# Harmony Ranch Subdivision Improvement Plans

WEBER COUNTY, UTAH  
APRIL 2021

**Harmony Ranch Subdivision**  
 WEBER COUNTY, UTAH  
**Cover/Index Sheet**

**Harmony Ranch Subdivision**  
 WEBER COUNTY, UTAH  
**Grading & Drainage Plan**

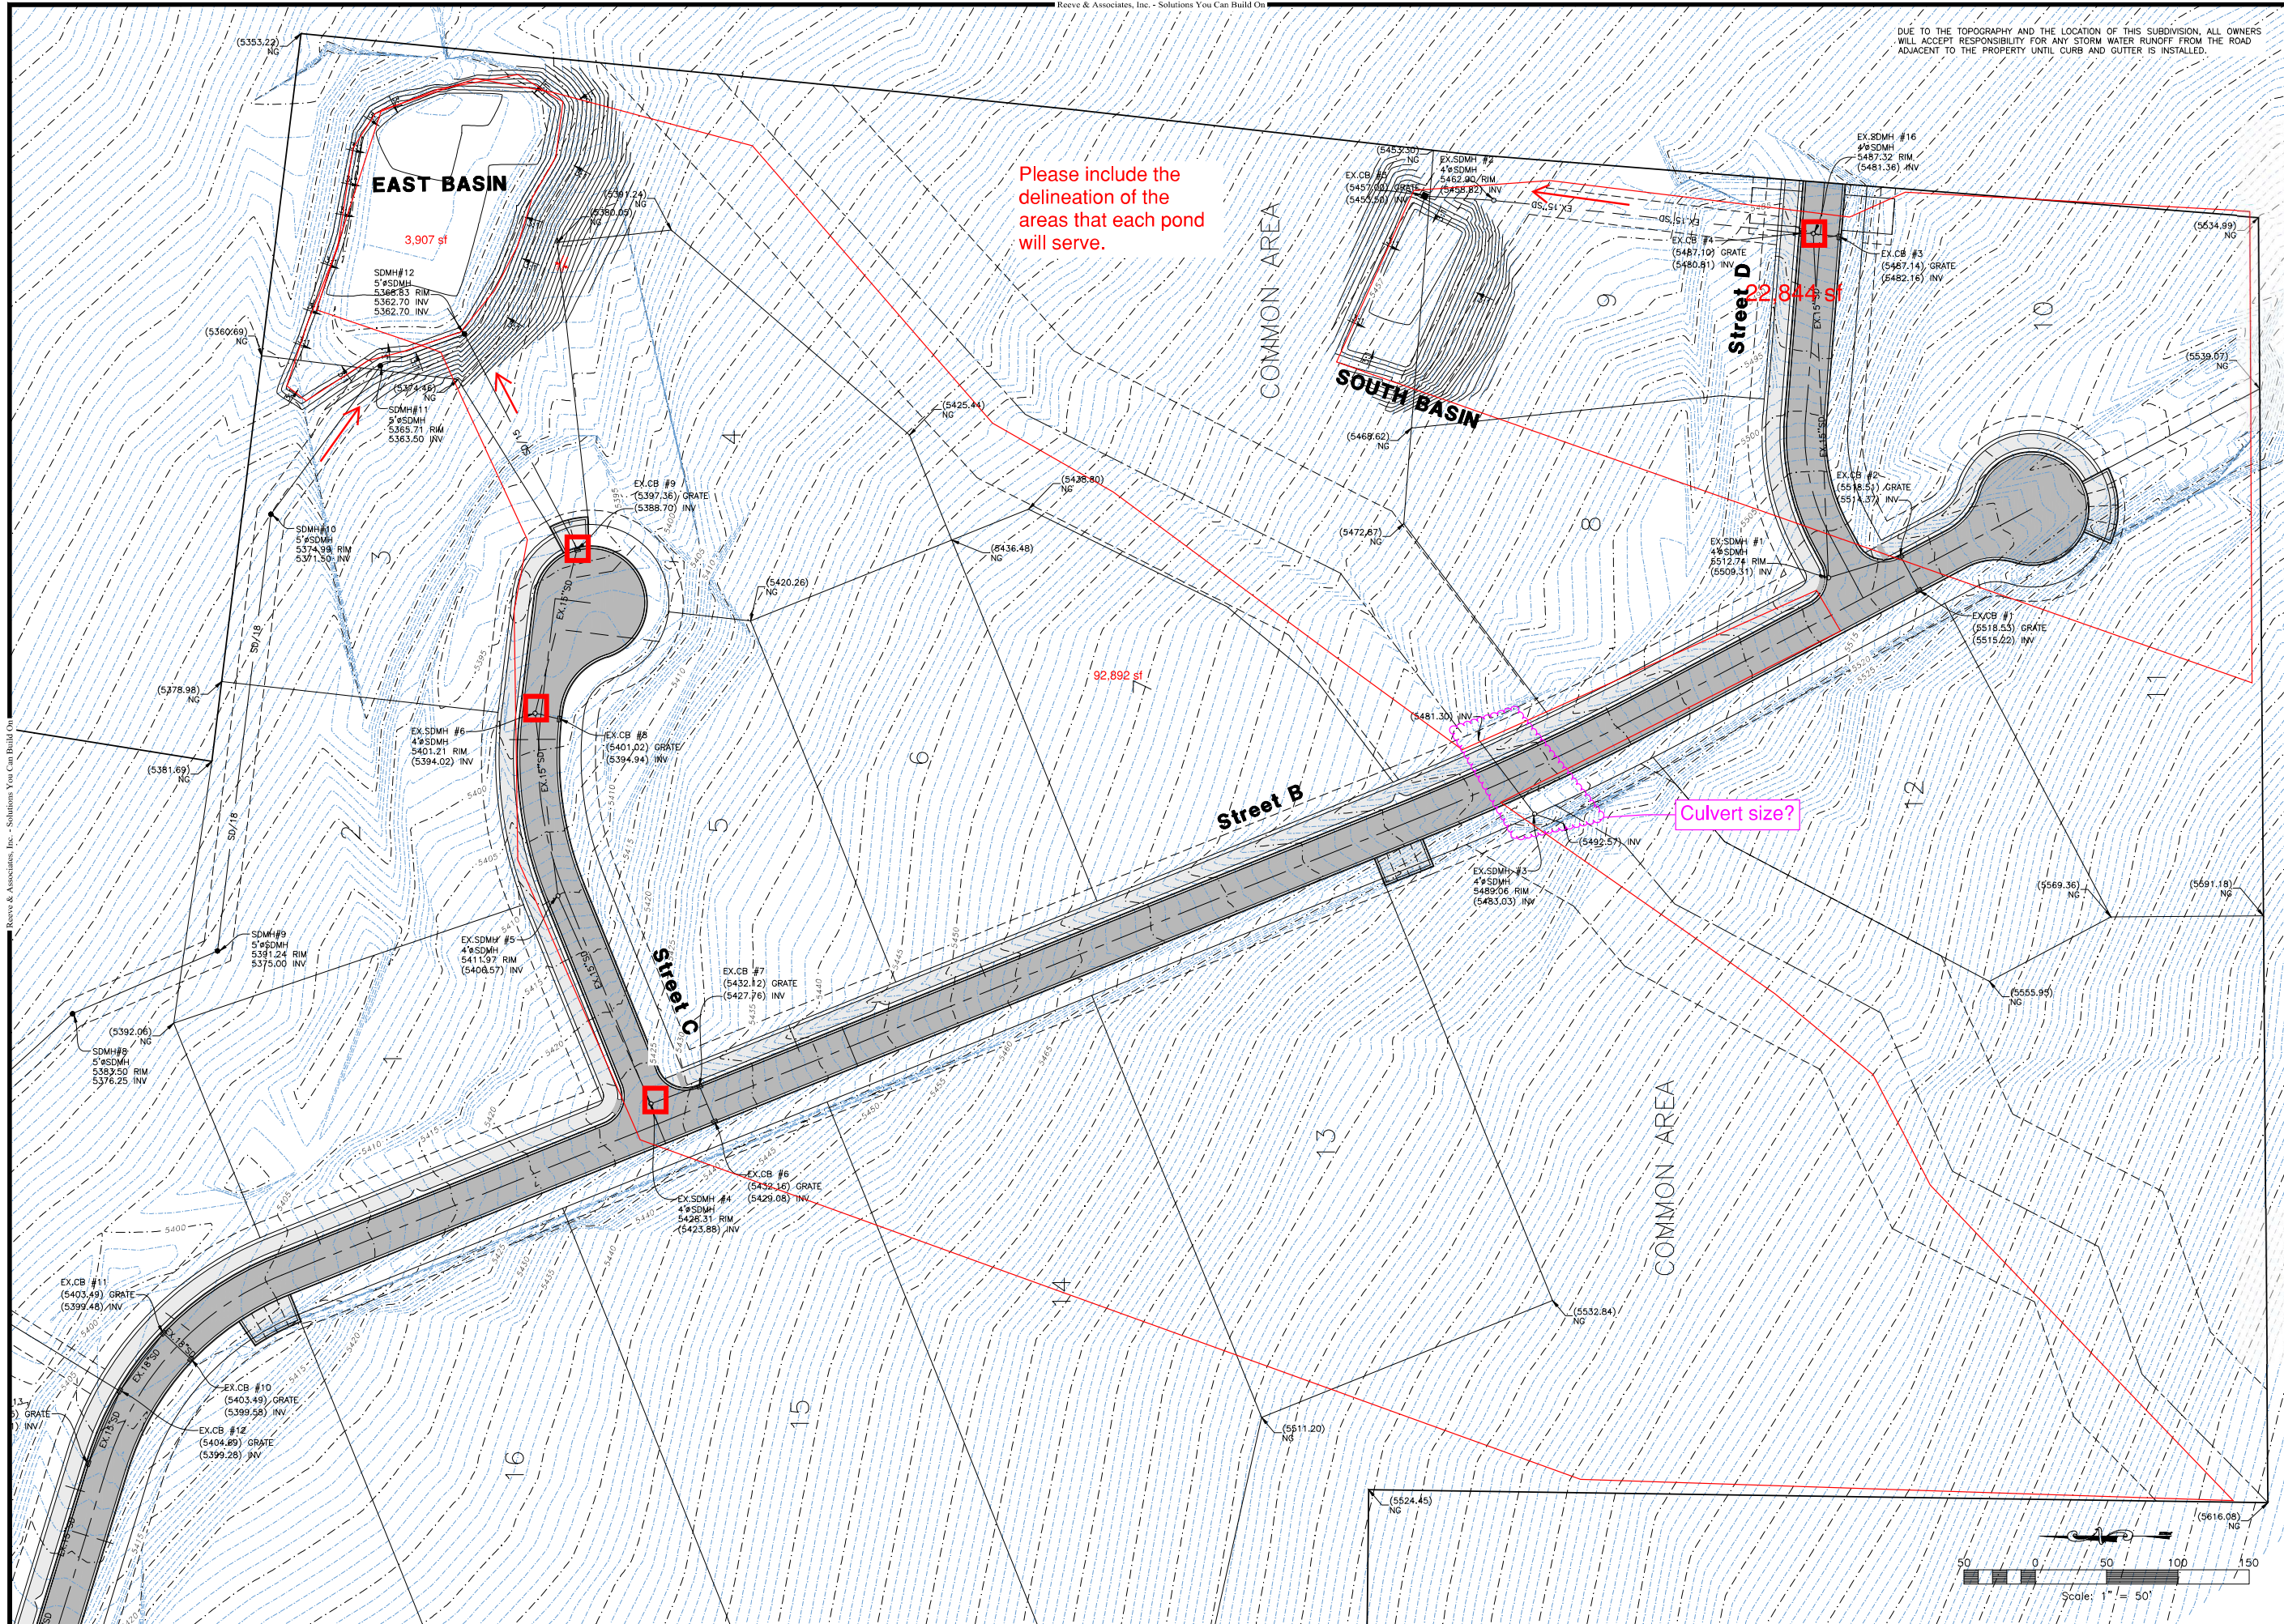
Please include the delineation of the areas that each pond will serve.

Culvert size?

**Harmony Ranch Subdivision**  
 WEBER COUNTY, UTAH  
**Utility Plan**

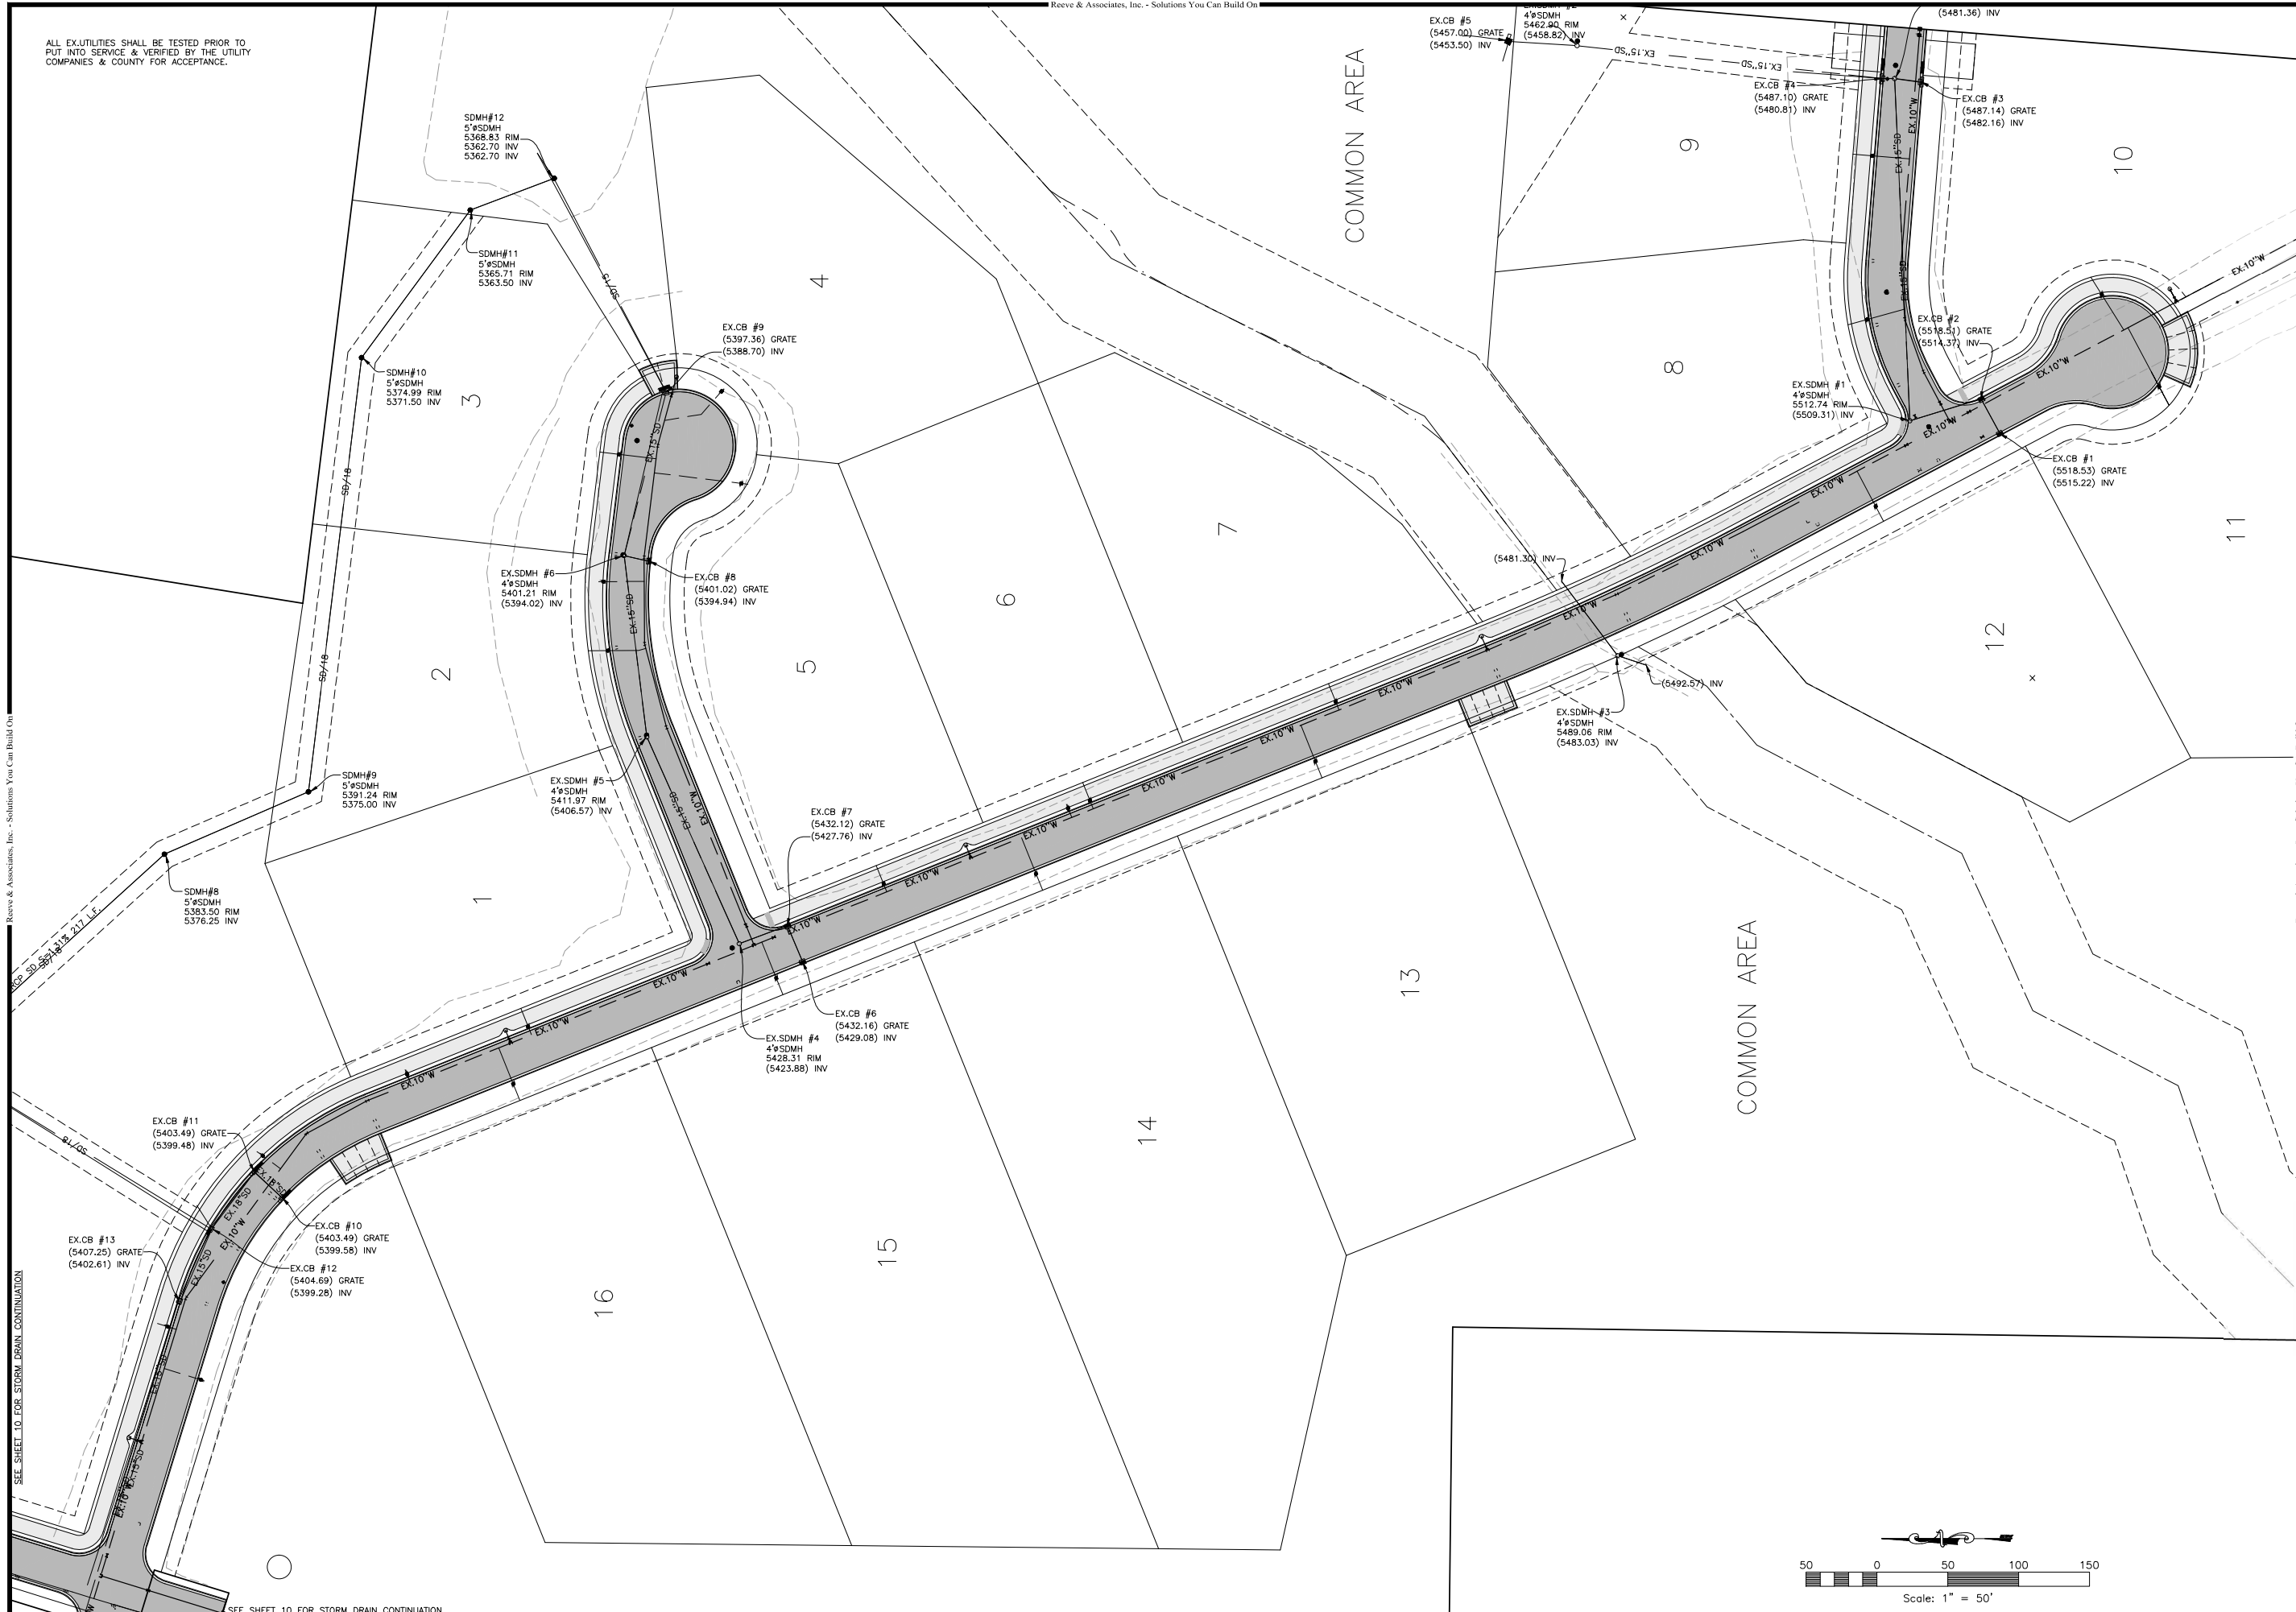
Is this from infiltration?

**Harmony Ranch Subdivision**  
 WEBER COUNTY, UTAH  
**Utility Plan**

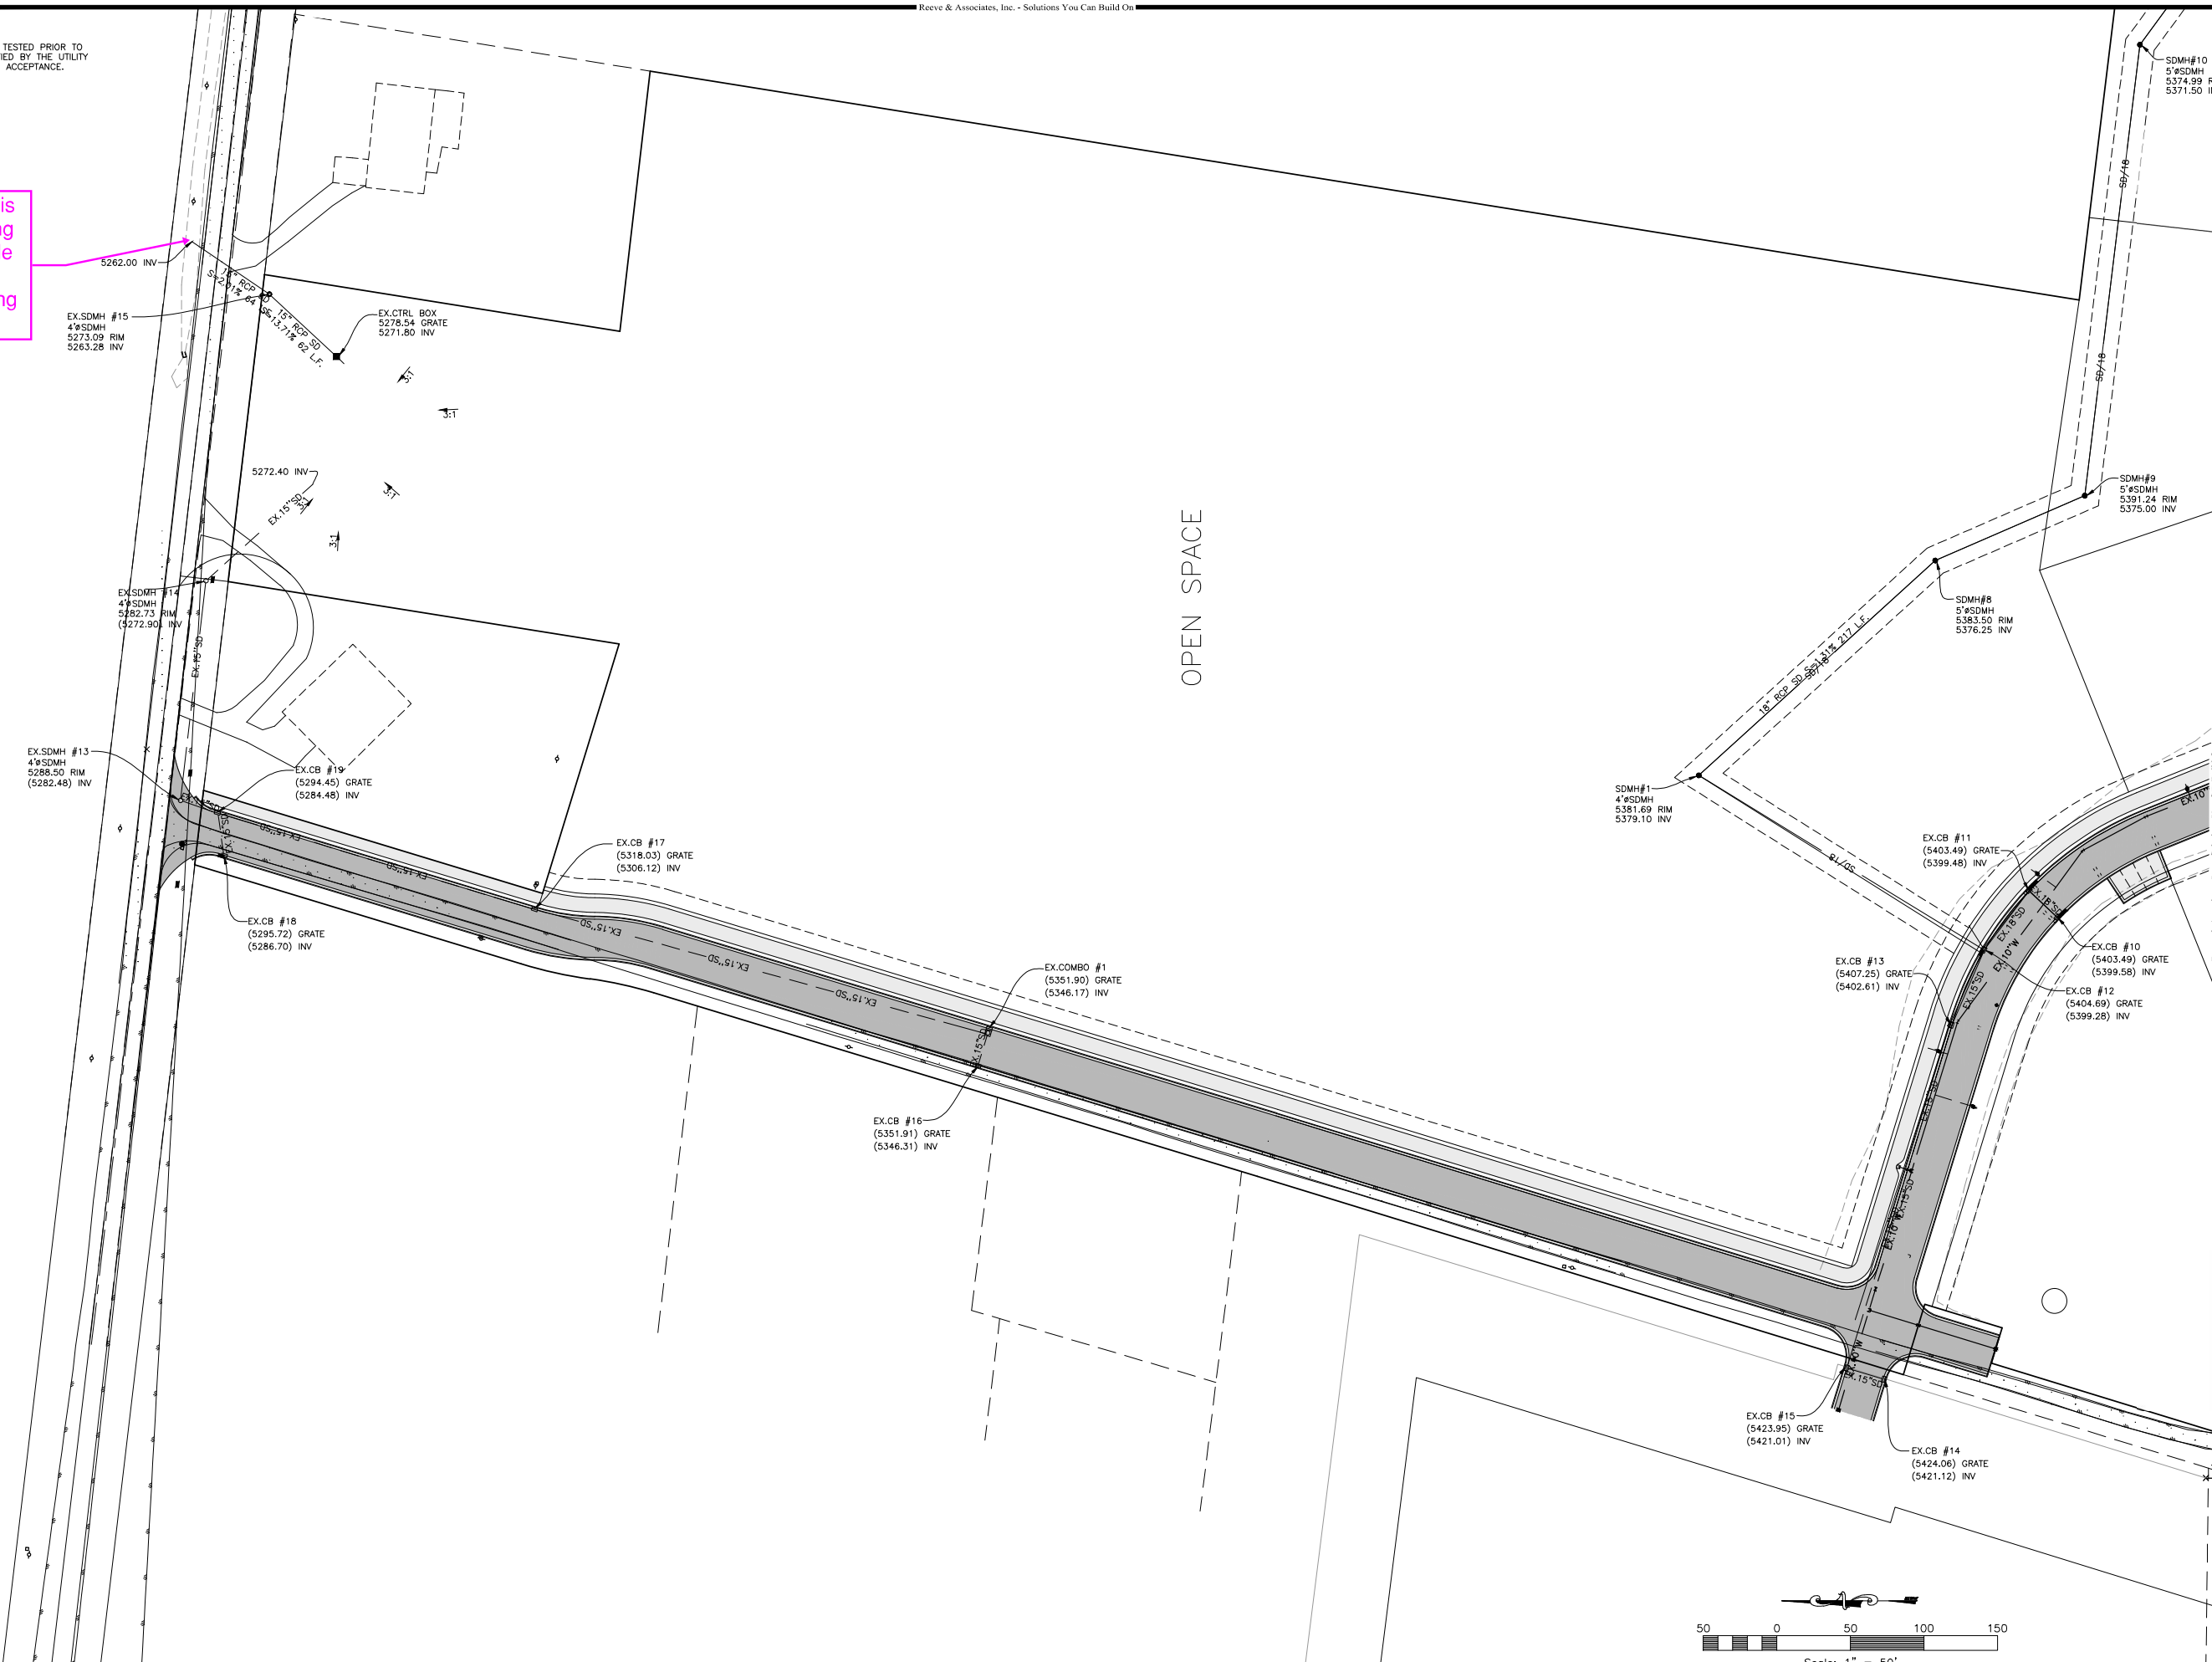
What is this discharging to? Provide info on surrounding grades.
